Determination 2020/031

Regarding the purported refusal to issue a building consent for the construction of retaining walls and associated drainage at 16 Newark Close, Tauranga

Figure 2: Retaining wall locations and drainage (Walls A to K)

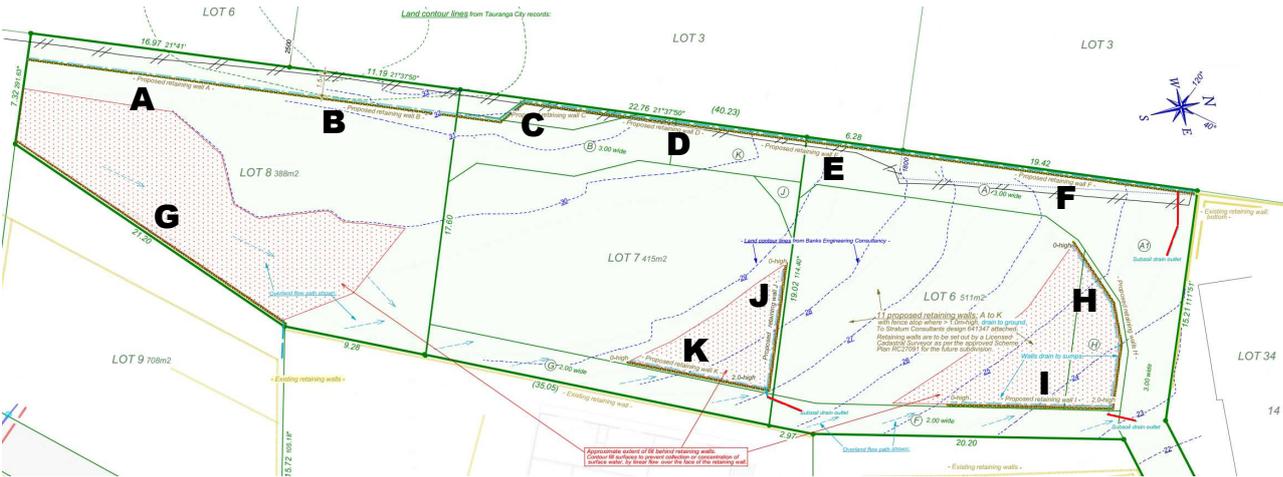
Date	Author	Response
11 Nov 2019	The authority	RFI includes queries re the wall design, “[surface water] specific design” and disposal.
3 Dec 2019	The agent	Sends updated wall plan dated 25 November 2019, says: “The discharge of the drainage from the retaining wall backfill groundwater, via the sump, is to be to the ground surface as overland flow towards the north east access way.”
11 Dec 2019	The authority	“s/w ¹⁰ drainage to land is not allowed because the concentrated flow may possibly occur. It has to be discharged into s/w system, as per the requirements of the Geotechnical report – 8.4 Stormwater. Not resolved.”

Date	Author	Response
12 Dec 2019	The agent	<p>Says the geotechnical report section 8.4 applies to “stormwater from roof and hard surfaces” which is surface water as defined in the Building Code (the agent provides the definition of surface water from Clause A2); adds that ground water (i.e. sub-surface water) that may be collected by the drainage coils behind the retaining walls is excluded from Clause E1 in the definitions.</p> <p>Says the geotechnical report’s conclusion refers to specific design of the retaining walls and stormwater disposal being required. Also says the “proposed method of discharge” from the drainage coils is included in the applicant’s consultants’ specific design for the retaining walls.</p>
30 Jan 2020	The authority	<p>“Please amend the plans regarding the drainage work as per [a separate building consent application for a different site]. Not resolved. Please direct the concentrated stormwater discharge from the retaining walls to an appropriate outfall (overland flow is not permitted as it has been collected and concentrated).</p> <p>[Clause] E1 states that surface water is All naturally occurring water, other than sub-surface water, which results from rainfall on the site or water flowing onto the site, including that flowing from a drain, stream, river, lake or sea. [The authority] refutes your argument that this is sub-surface water because the rainfall lands on your site, is then concentrated and may for a time be sub-surface water as it drains through the retaining wall drainage material and then exits the [drainage coils] as surface water in a concentrated flow. The application has still not demonstrated compliance with [Clause] E1. Not resolved.”</p>

Figure 3: Extract from retaining wall design (Walls A to E), drawing dated 16 January 2020

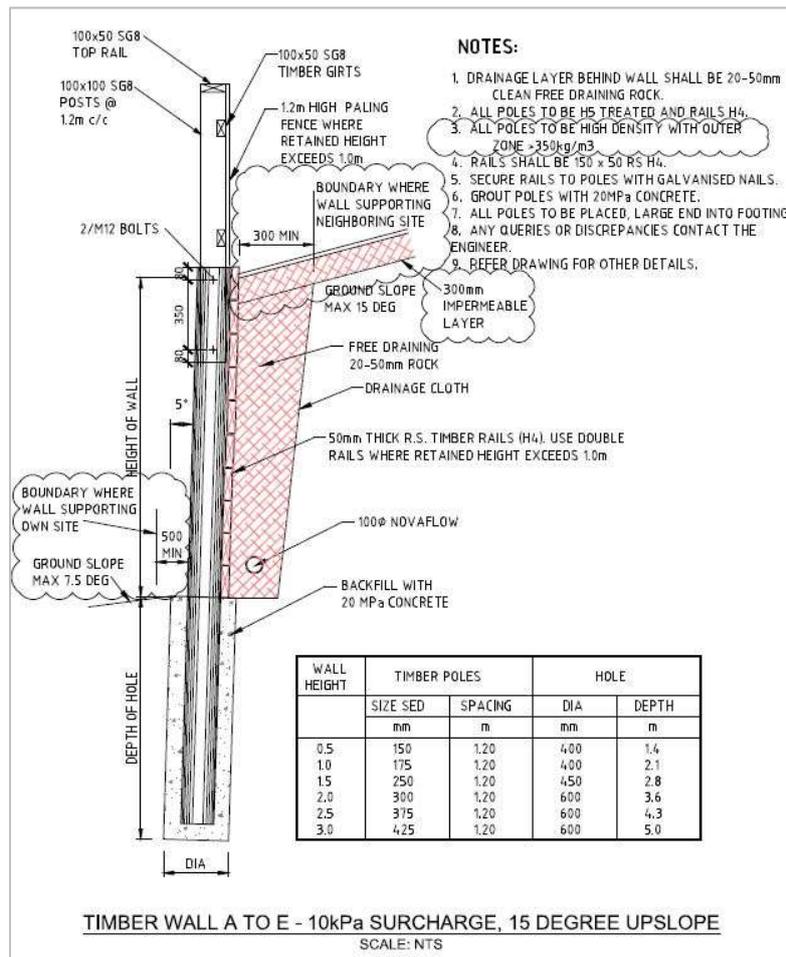
- A drainage layer of 20-50mm “clean free draining rock” sits behind, and extends the height of, each retaining wall (as shown in Figure 3). This layer is at least 300mm wide at the top and is backed with drainage cloth. The drainage layer is capped with an impermeable layer 300mm thick that extends a short distance along the adjacent ground. At the base of the drainage layer is a 100mm diameter perforated drainage coil (“the drainage coil”). Outlets for these drainage coils are indicated in Figure 2.

- 3.1.4 In the agent’s view, the impermeable layer detailed for the retaining walls would seal the ground surface from the free draining backfill, preventing the ingress of surface water into this backfill, and any water within the free draining backfill was “excluded sub-surface water” as per the definition in the Building Code.

- 4.3.1 In considering whether the water collected by the drainage coils is surface water and must comply with Clause E1 I have taken into account the design of the retaining walls and associated drainage. As described earlier in this determination and illustrated in Figure 3, there is a layer of drainage metal behind each retaining wall which is backed by drainage cloth. At the base of the retaining wall there is a perforated drainage coil; at the top of the retaining wall is a 300mm thick impermeable layer extending across the top of the drainage metal, and for a short distance along the adjacent slope.

- 4.3.2 In my view the wall's design, and the impermeable layer in particular, would prevent rainwater (surface water) hitting the ground above the retaining walls from flowing down through the drainage metal and into the drainage coils. I also consider it unlikely that any significant rain water would penetrate the wall to the extent that it would be collected by the drainage coils. I consider the only water able to reach the drainage coils is sub-surface water seeping through from the retained slopes.

- 4.3.3 Accordingly, I consider that Clause E1's requirements for the disposal of surface water do not apply to the water arriving at the drainage coils.

- 4.3.4 In conclusion, I consider the authority was incorrect to regard water from the drainage coils as surface water and to refuse a building consent on the basis that its disposal was not in accordance with Clause E1.
